Remarks

Claims 1-8 were originally pending in this application. By this amendment, claims 1 – 3, 5 – 6, and 8 have been amended. Claim 4 has been canceled. Claim 7 is unchanged.

FIG 1
(PRIOR ART)

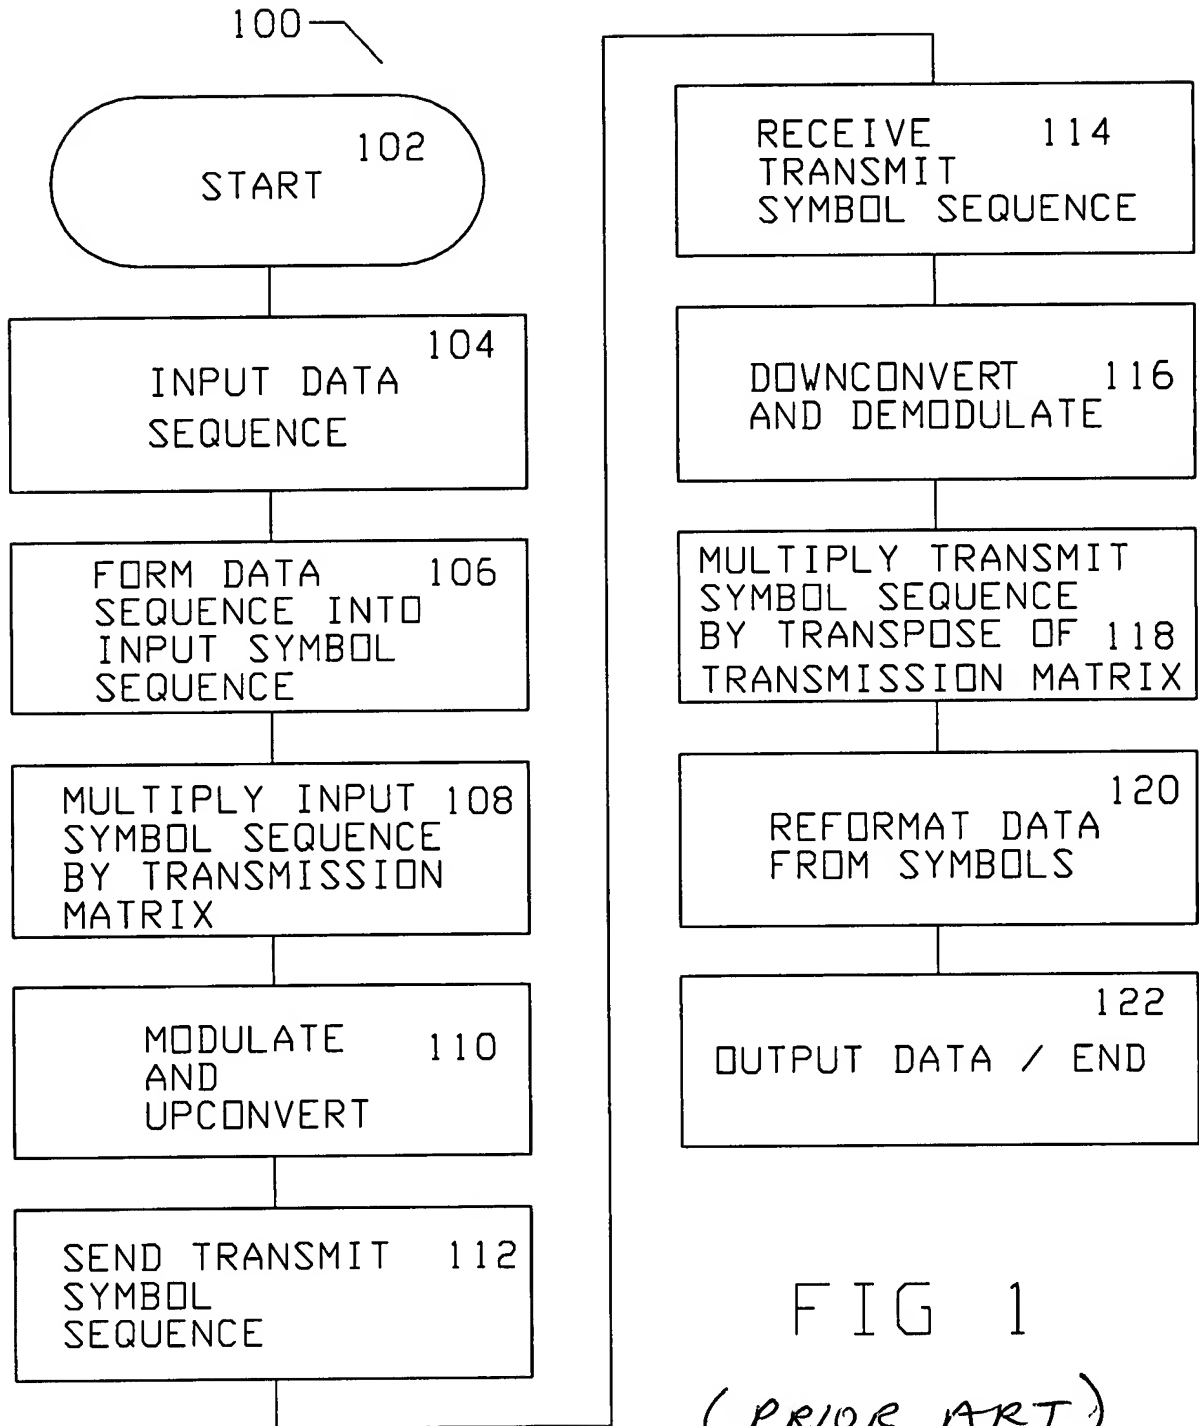
"(PRIOR ART)" is be added underneath "FIG 1" in a replacement sheet FIG 1.
